CITY OF MERCER ISLAND

STAFF REPORT

DESIGN COMMISSION DESIGN REVIEW

Project No:	DSR19-017
Description:	Upgrades to North Mercer Pump Station (NMPS), including: <ol style="list-style-type: none">1. Upgrade and expansion of existing building;2. Construction of a new building and concrete pad to house standby generator and fuel tank;3. Installation a new restroom and odor control fan; and4. Construction of a temporary pump station to manage flows during construction.
Applicant/ Owner:	King County Wastewater Treatment Division
Site Address:	7631 SE 22nd St (Parcel Number 531510-1946)
Zoning District	R-8.4
Staff Contact:	Robin Proebsting, Senior Planner
Exhibits:	<ol style="list-style-type: none">1. Application2. Plan set for North Mercer Pump Station (NMPS) Upgrade prepared by Tetra Tech and Jacobs, dated December 20193. Notice of Application, dated December 30, 20194. Notice of Public Hearing, dated September 28, 20205. Determination of Nonsignificance issued by Jim Sussex, King County Wastewater Treatment Division Water Quality Planner, dated May 23, 20196. SEPA Checklist prepared by Katherine Fischer, King County Wastewater Treatment Division Environmental Programs Managing Superv

DCN:	DATE: 12/16/2019
PROJECT FILE NO:	DRAWING NO: A100
SHT NO / TOTAL 129 /	REV NO:

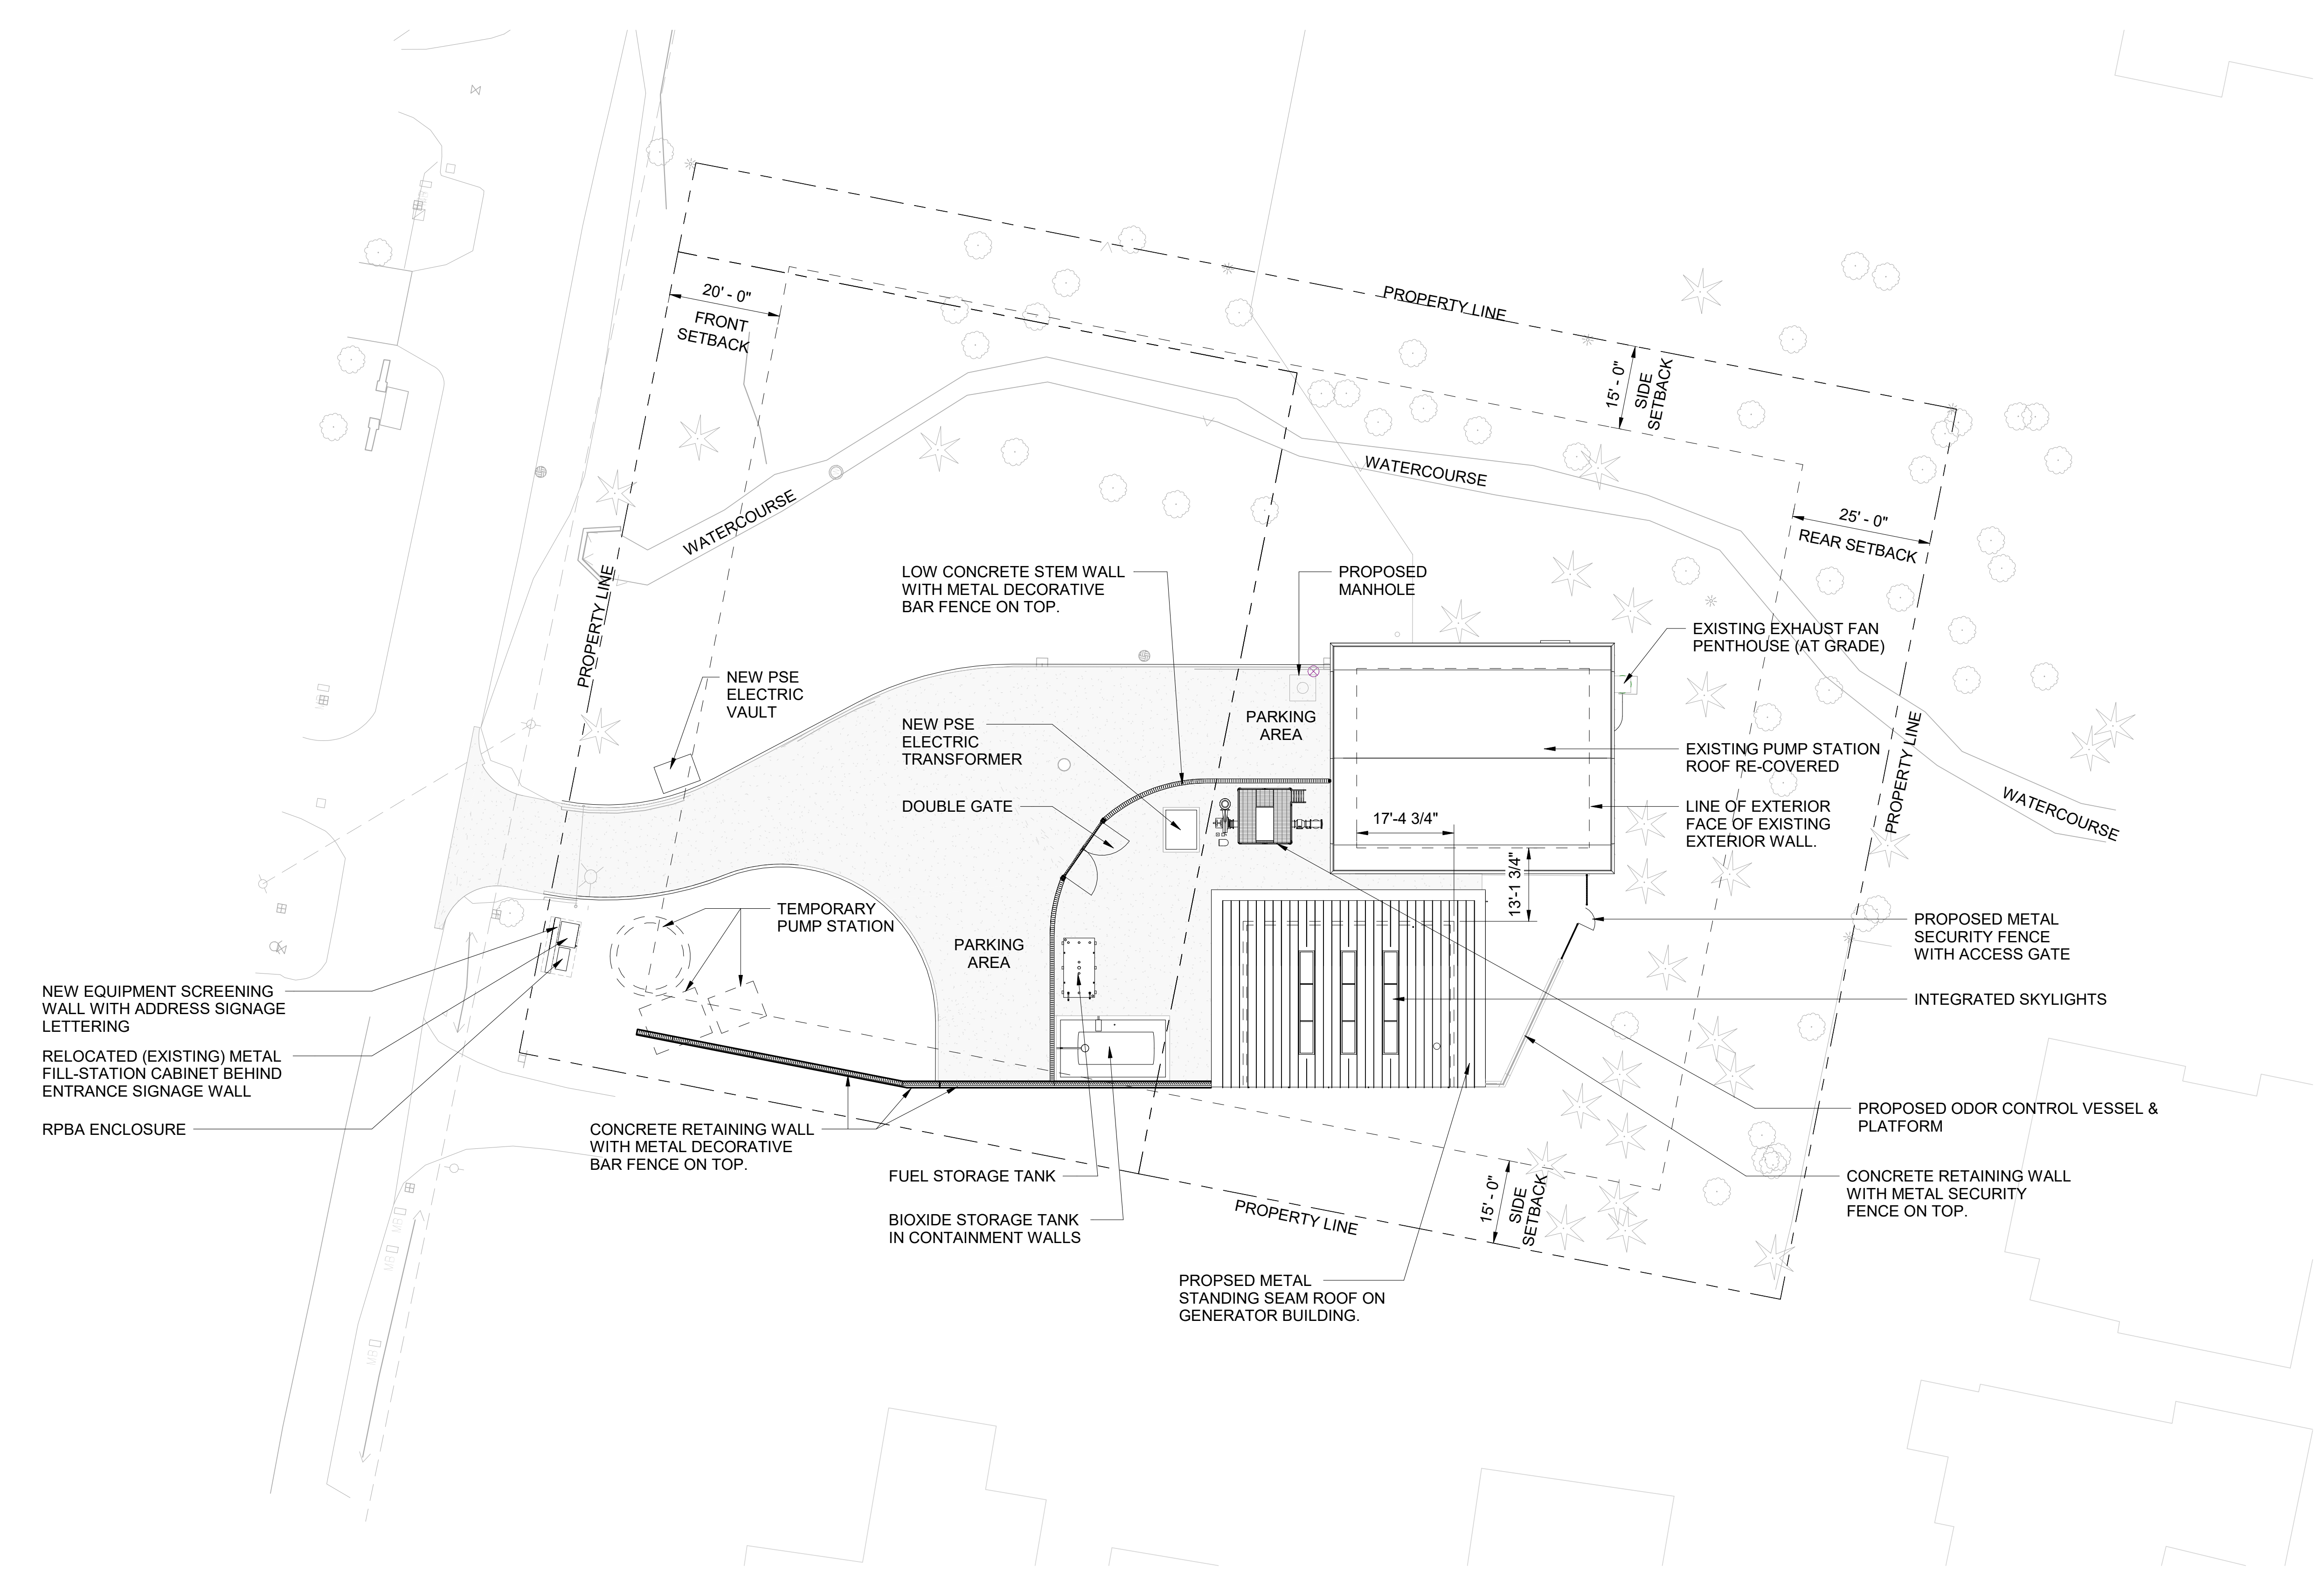
Staff Analysis: No surface parking lot is proposed for this site. Parking will consist of a driveway and turnaround (Exhibit 2, Sheet A100). The parking lot criteria do not apply.

MICC 19.02.020.C Yard Requirements	1.a. <i>Front Yard depth: 20 feet or more</i> <i>Rear Yard depth: 25 feet or more</i> <i>Side Yard: Sum of side yards shall be a width that is equal to at last 17% of the lot width</i>	Figure A100 shows yard depths as noted in section 19.02.020.C. Note that fences and retaining wall are allowed in yard areas per section 19.02.050. Retaining walls in yard areas must be less than 144 inches in height per section 19.02.050.D.4.a. Max height of the proposed retaining wall is 83 inches. Lot width is approximately 162-feet, making total side yard required 27.54-feet. A100 currently shows two 15 foot deep yards, for 30 feet total.

DCN:	DATE: 12/16/2019
PROJECT FILE NO:	
DRAWING NO: A101	
SHT NO. / TOTAL: 130 /	REV NO.:

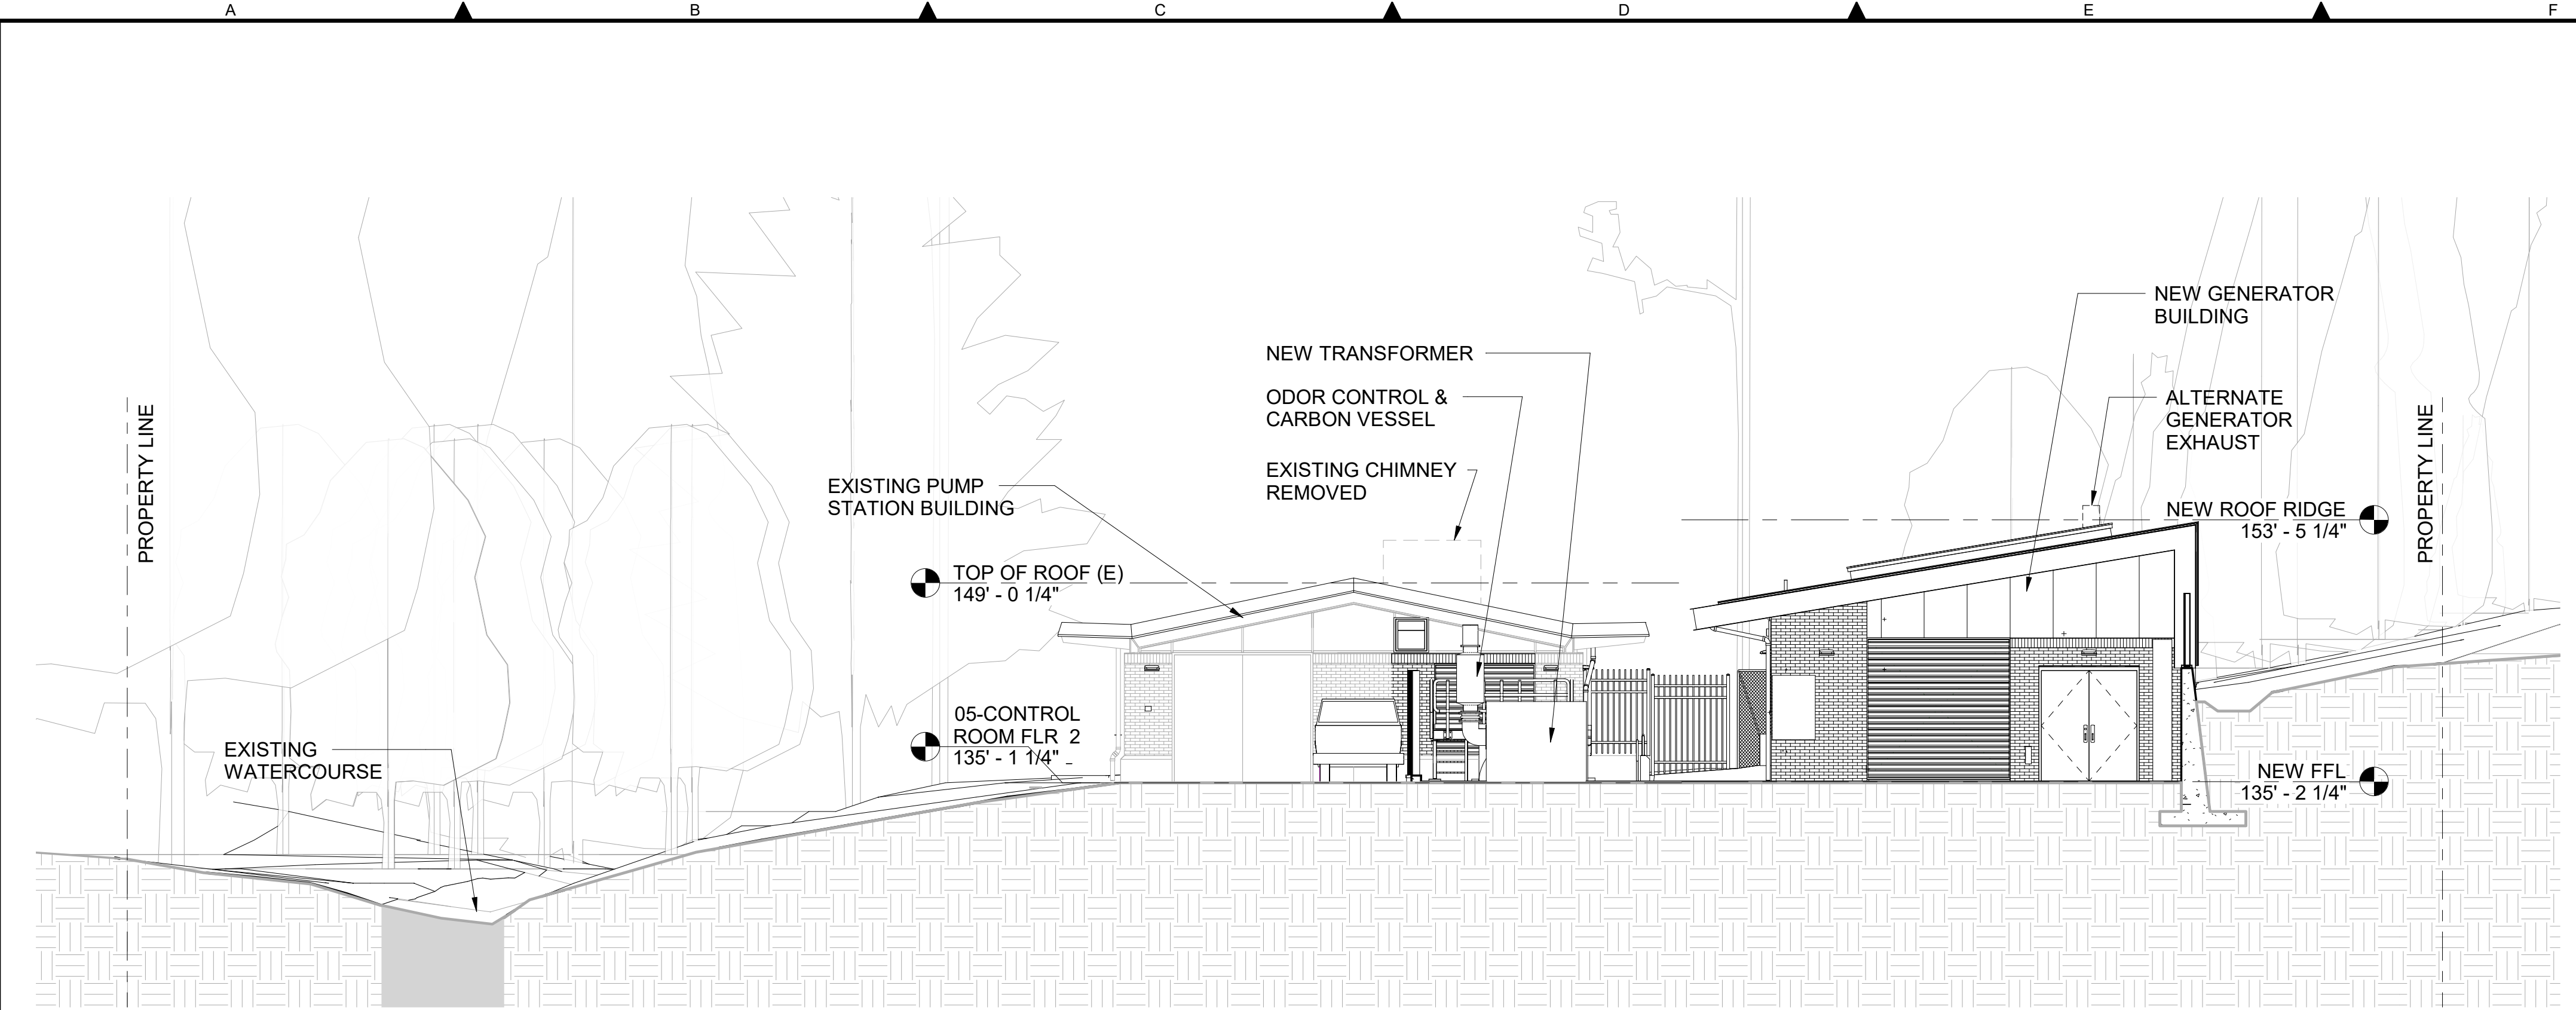
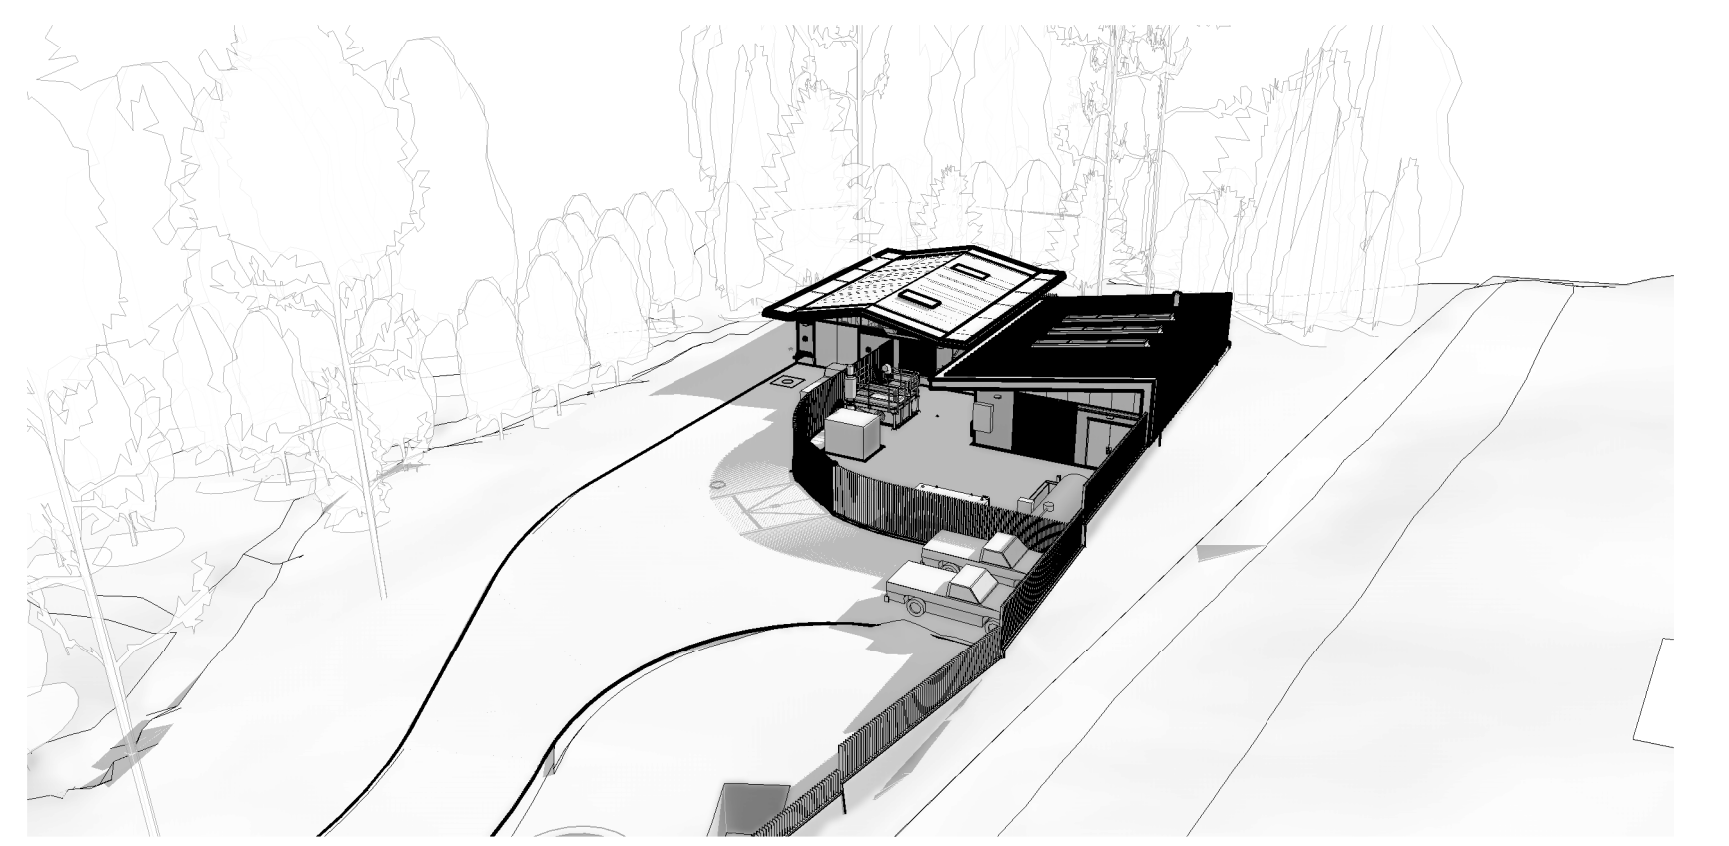
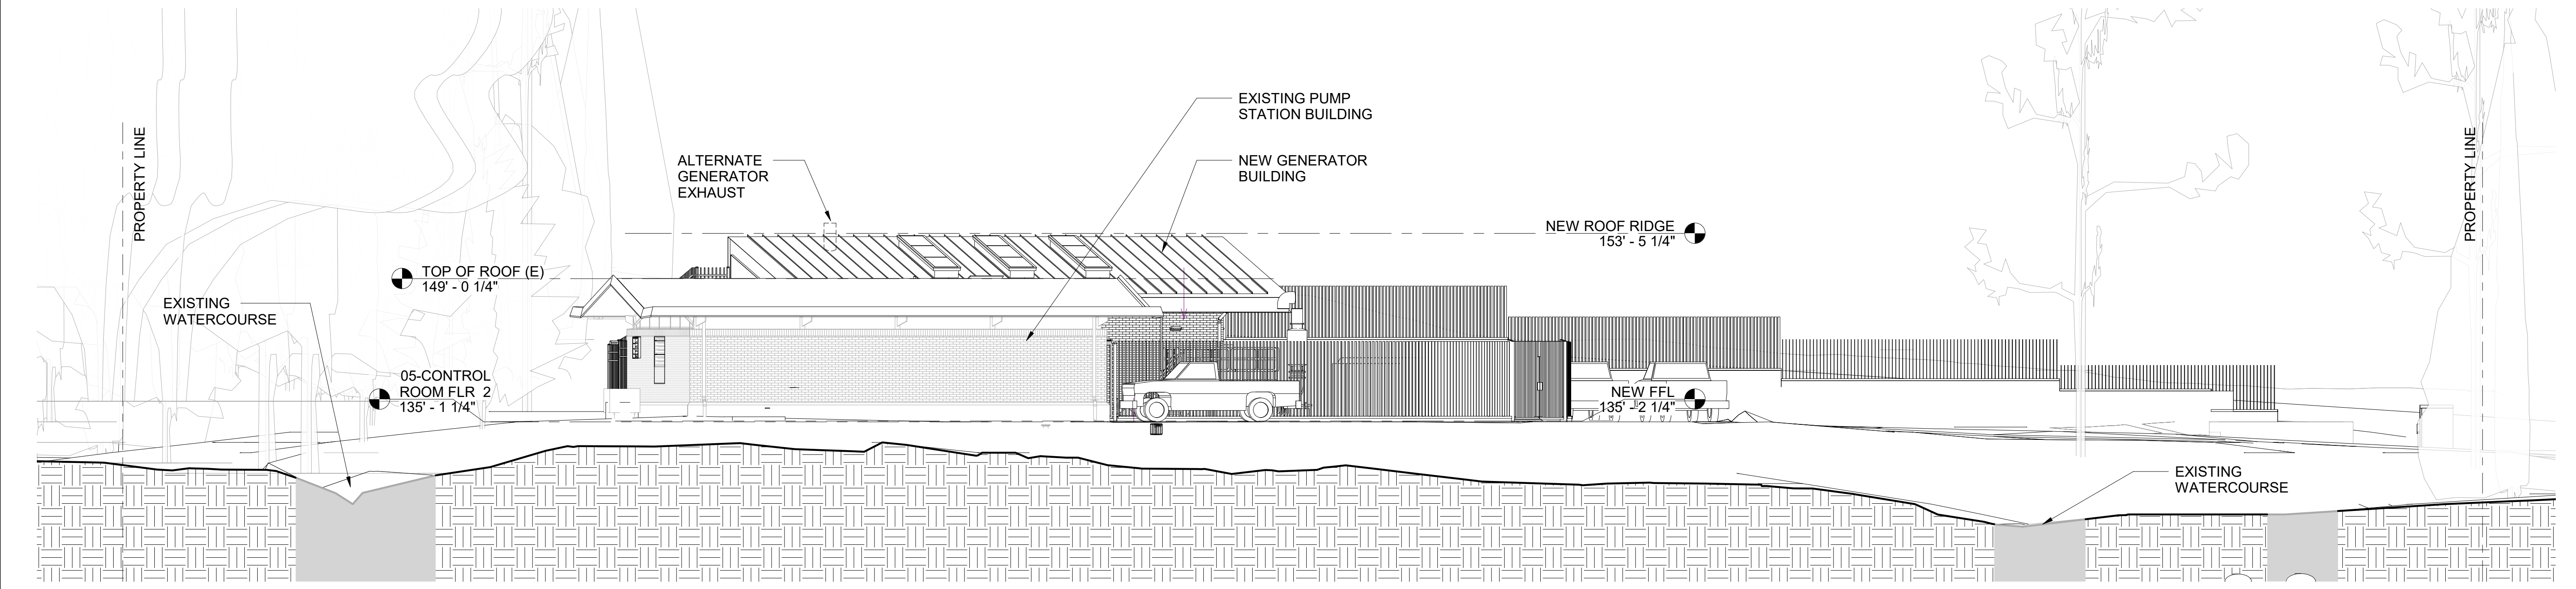
The proposed building will resemble a single-family residence, in keeping with the scale and context of the residential neighborhood (Exhibit 2, sheet A101). With the addition of the new generator building, there will be multiple structures on site. The new generator building has been designed to use existing topography to its advantage to keep the new roofline as low as possible and is similar to the existing pump station building in design. More detailing and material composition have been applied to the north elevation of the new building, as this will be the only side of the building facing the street (Exhibit 2, sheet A304a). The standing seam will also provide pattern and depth to the elevation facing west as a backdrop to the landscaping. A complimentary material palette has been selected to blend the new building with the existing one (Exhibit 2, page 36 of 47).
